## **Manufacturability Analysis Report**

- QC113270005
- 08/02/2024 V1

Part Name: 309805.STL

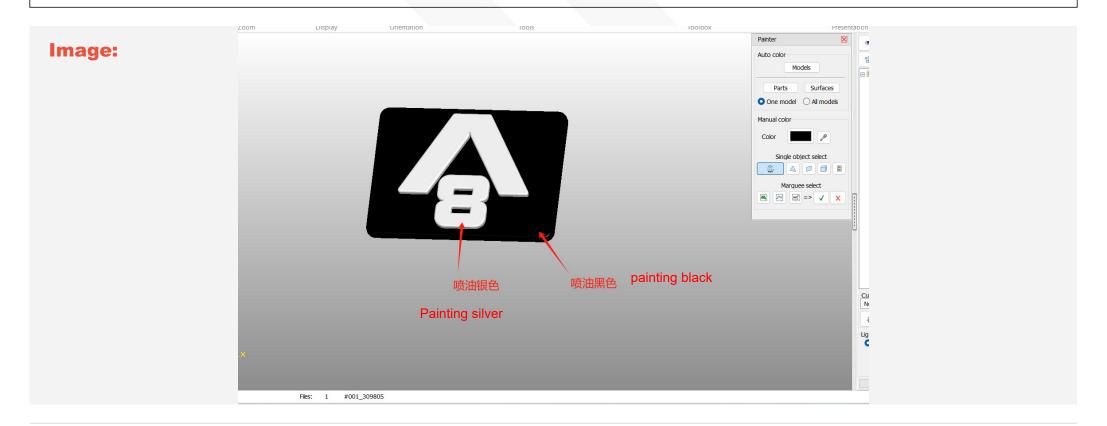
**Detail:** Do you need to paint for your parts? If the parts need to be beautiful, it is recommended to be grind and then painted as shown in the attachment. If you only paint the font, the surface will be ugly. Because the black ABS material will be a little white after grinding, which will be not attractive. May I know your idea?

Part Name: 309805.STL

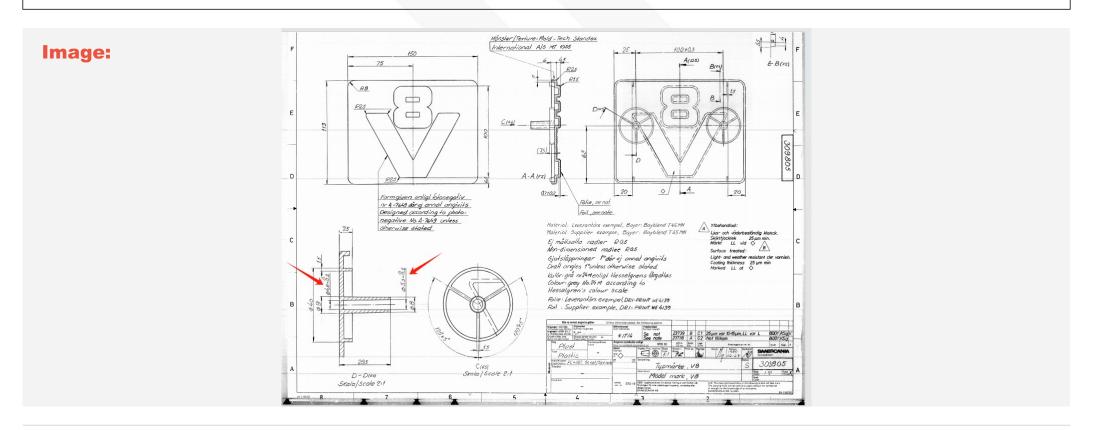
**Detail:** The tolerance of the area indicated by the arrow is not achievable by 3D printing and needs to be relaxed to + 0.30/+0 mm.
